**RE: PEER REVIEW DESIGN SERVICES STATEMENT OF QUALIFICATIONS**

**RE: 14329 Mulberry Drive**

**RE: 15600 & 15650 Los Gatos Blvd.**

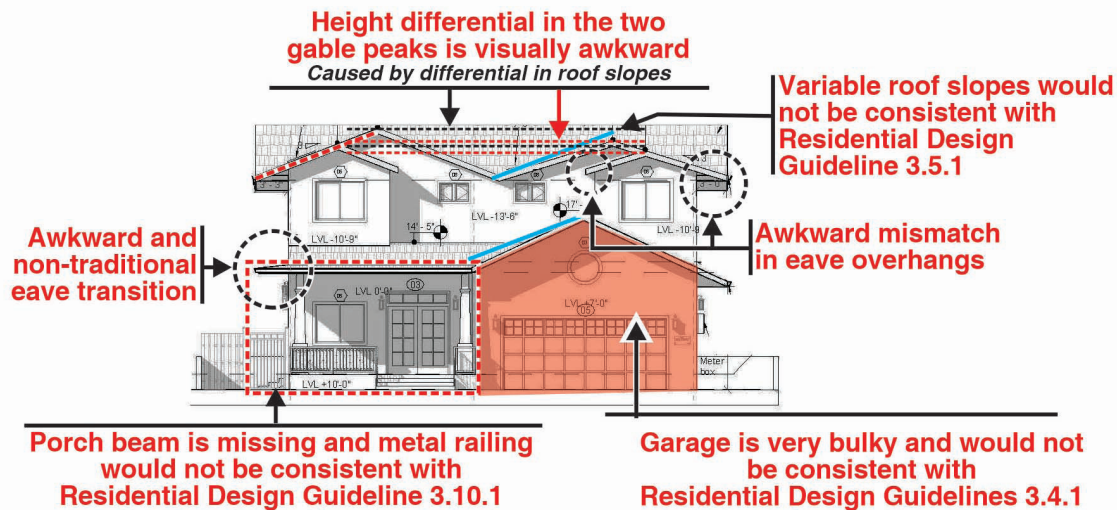
The proposed design is good from the standpoint that it is a recognizable traditional residential design style that would fit comfortably into the immediate neighborhood. But there are many issues that need to be addressed to bring it into better conformance with the Town's Residential Design Guidelines and traditional detailing.

1. The garage gable is quite large and dominates the front facade. It would not be consistent with Residential Design Guideline 3.4.1.

2. The roof slopes are somewhat variable, and overly complex which would not be consistent with Residential Design Guidelines 3.5.1 and 3.5.2.

1. Eliminate the gable roof at the garage and extend the porch roof over the garage.
2. Increase the consistency of the roof slopes (6:12 shown), and provide more uniformity to the front facade roof gables and bay windows.
3. Revise the transition of the porch roof to the left side facade to reduce the tall wall expanse.
4. Add window on the second floor front facade which currently is quite blank.
5. Add a beam at the front entry porch, refine the column bases and caps, and use a wood railing rather than the proposed metal railing.

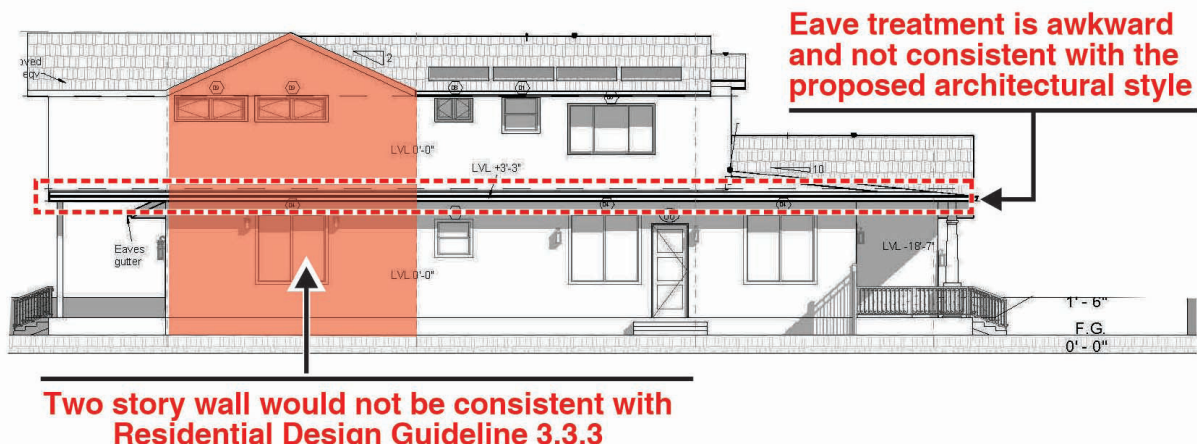
3. The height differential between the gable peaks on the second floor projecting bay windows is visually awkward. The differential is caused by the lack of consistent roof slopes - see comment #2 above.
4. The first floor roof transition between the front porch roof and the left side facade is very awkward and non-traditional.
5. The lack of a beam at the front porch and a metal railing would not be consistent with Residential Design Guideline 3.10.1. Also, some porch elements need further refinement.

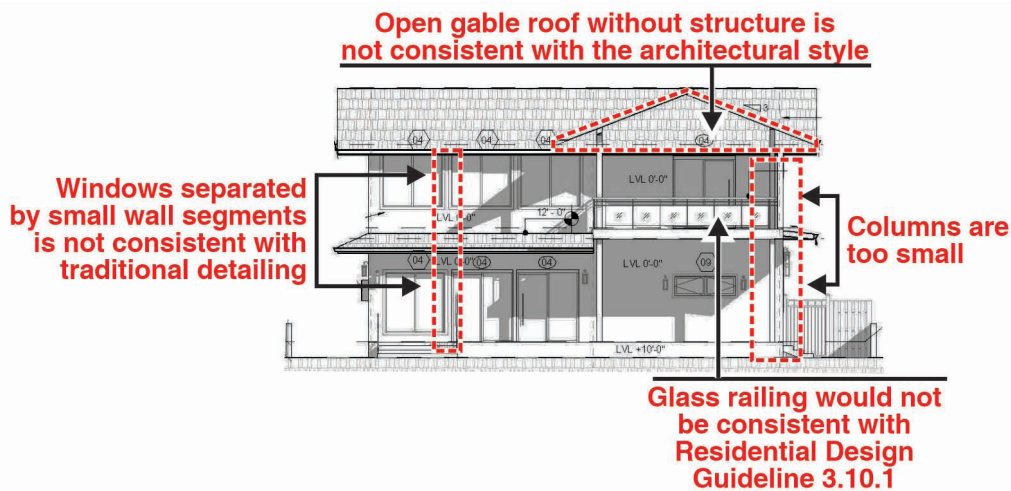
6. The two story gable walls on the side elevations are adding unnecessary complexity to the roof form and, as currently designed, not consistent with Residential Design Guideline 3.3.3.

7. The open gable roof without supporting structure on the rear facade is not consistent with the architectural style.

8. The rear deck columns are too small and the proposed glass railings would not be consistent with the style.

6. Eliminate the side facade gables/ This would still provide a generous, high ceiling in the Master Bedroom. Some examples are shown below.

7. Add a roof truss to the rear facade second floor deck. Two examples are shown below.

8. Refine the second floor deck columns, column bases and railings to match the front entry porch.
9. Group the windows on the rear facade (see example below), or use smaller windows to allow more wall space between them.

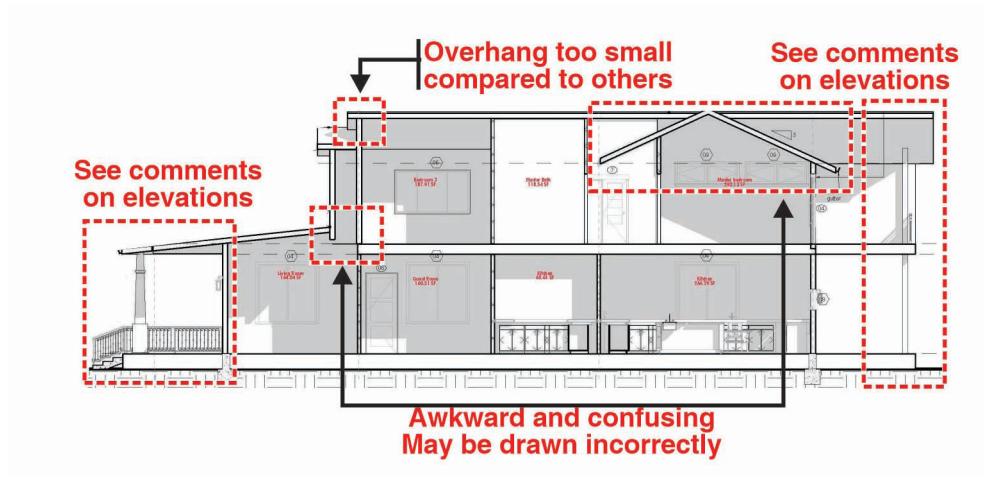
9. Note that the section shown below is quite incomplete and confusing. It does, however, highlight the issue that roof overhangs seem to vary which would not be consistent with the architectural style and Residential Design Guideline 3.5.3.

10. Provide consistency on all roof overhangs - see concern #9 and illustration on page 6
11. Recess the garage door per Residential Design Guideline 3.4.1.

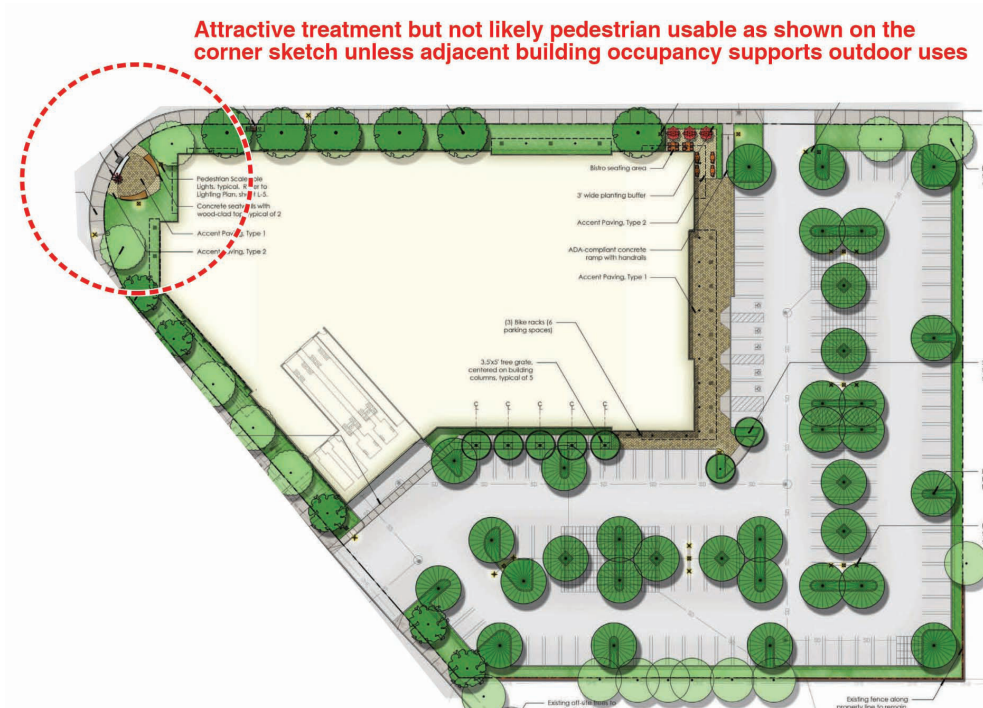
1. The site plan works well with parking frontages along Los Gatos Blvd. and Los Gatos-Almaden Road limited in length. There could be an issue, however, with the truck loading area located at the project auto entry on Los Gatos-Almaden Road. Circulation conflicts between trucks and autos could be controlled by limiting the delivery time schedules. But, the truck maneuvering pattern to easily back into the truck bays is not clear.

2. Provisions for safe pedestrian circulation from parking at the northern edge of the parking lot to the building entry are well provided for, but similar accommodations have not been made for parking at the eastern edge of the site.

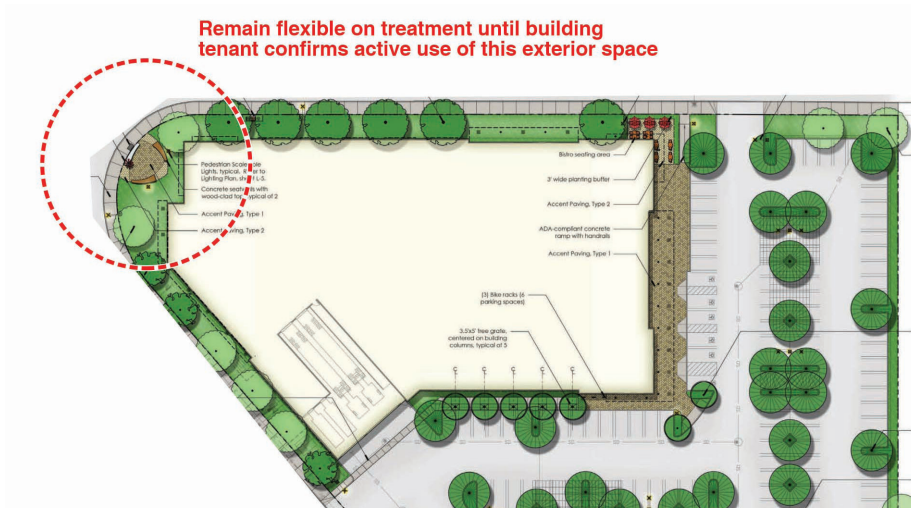
3. The proposed treatment at the intersection corner of the site appears attractive, but not likely pedestrian-usable as shown on the corner sketch below unless the adjacent building occupancy supports outdoor uses.

4. Remain flexible on the treatment of the Los Gatos Blvd /Los Gatos-Almaden Road intersection corner and the Los Gatos Blvd. facade fenestration until building tenant confirms potential interior uses. If not feasible as currently shown, add landscaping to the corner and investigate alternative treatments for the window areas. Some examples are shown below.
